Product / Process Change Notification (PCN)

PCN #: PCN_WL-SUMW_20220827

Affected Series: WL-SUMW; 15335337AA350

BEFORE CHANGE:

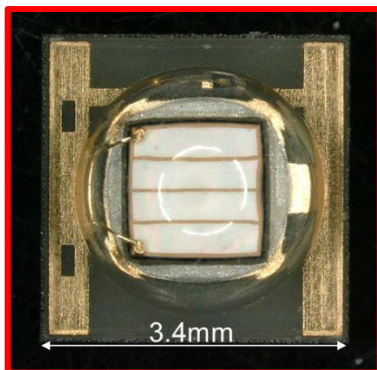
Detail of Change:

The chip will be replaced by a newer chip generation. There will be no change in the dimensions, electrical/optical parameters and reliability of the product.
